8023cg_D3p2_CMP_Substantive MDI Comments

**Milwaukee, WI
August 2019**

**Chris DiMinico
MC Communications/PHY-SI/SenTekse/Panduit
cdiminico@ieee.org**

Comment to 802.3cg D3p2

Test Configuration

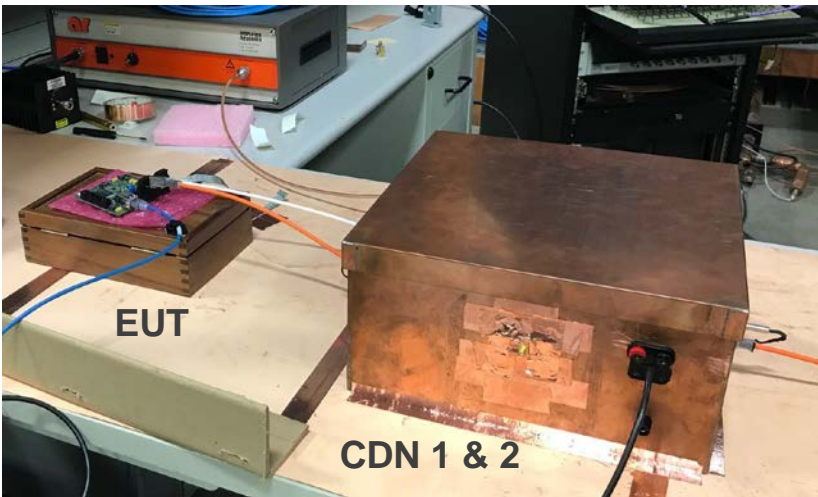
- Demonstrate 10BASE-T1L operation with E3 Conducted RF with IEC 63171-1 MDI.
 - Link segment of 1 Km - IL and RL not at worse case limit

Figure C.1 - 1000 m channel configuration

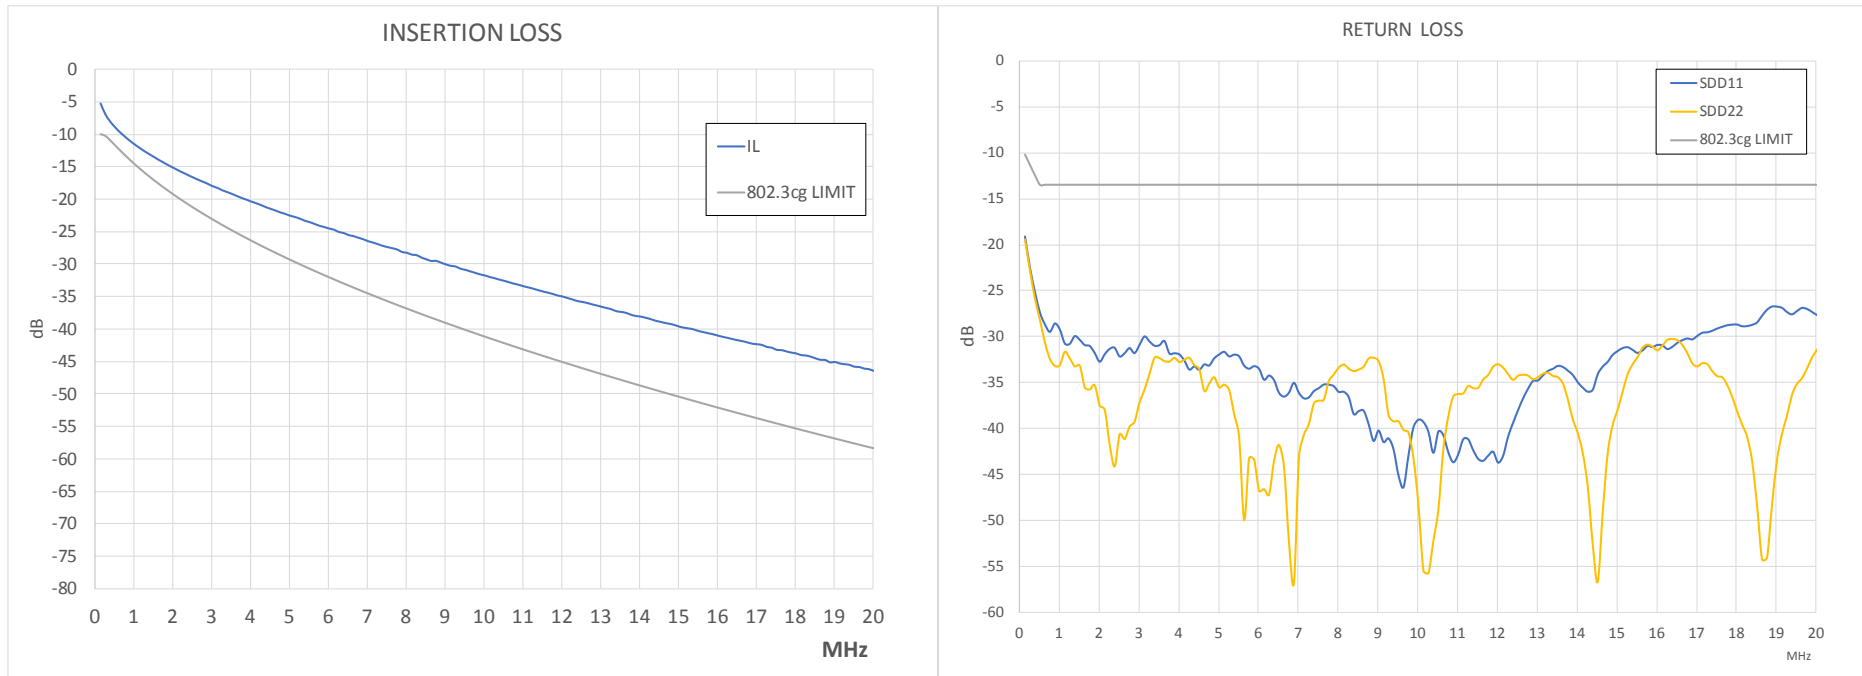
1 km balanced single twisted-pair 18 AWG 10 inline connectors, 2 MDIs

Conducted Immunity Result

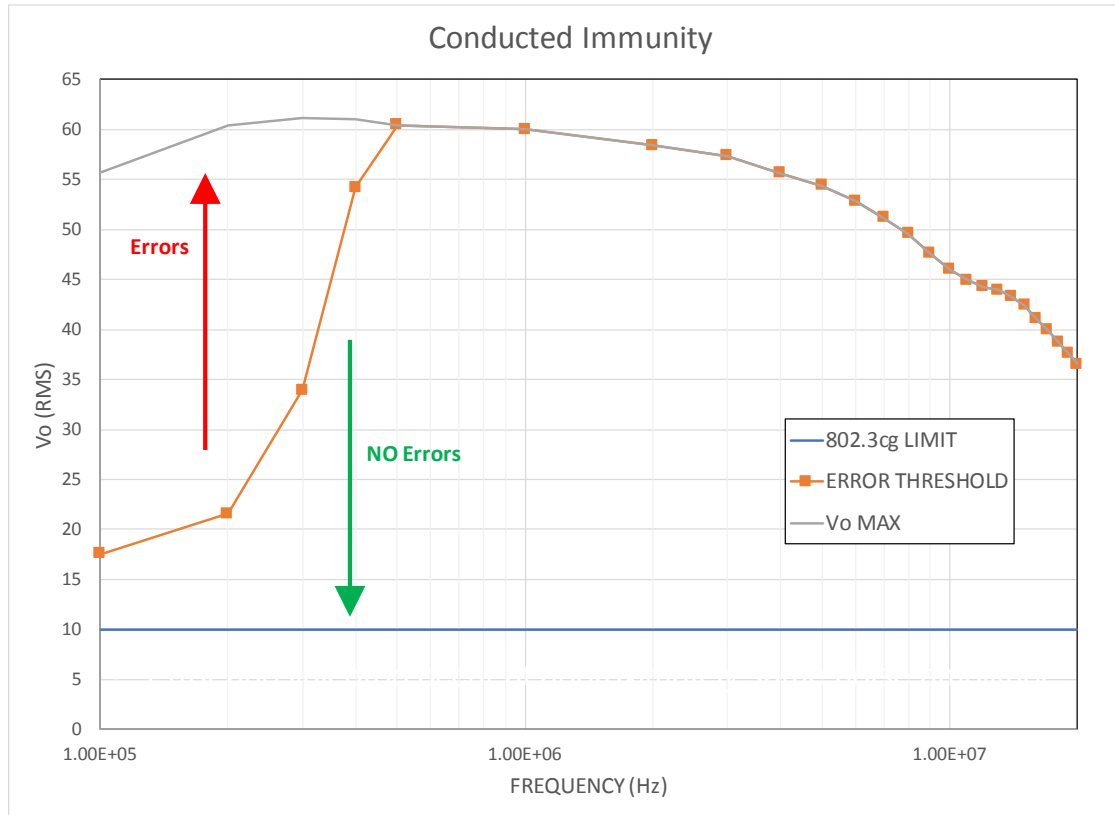
- Vo MAX is maximum attainable noise amplitude from test setup
- Error instance and link drop approximately coincidental
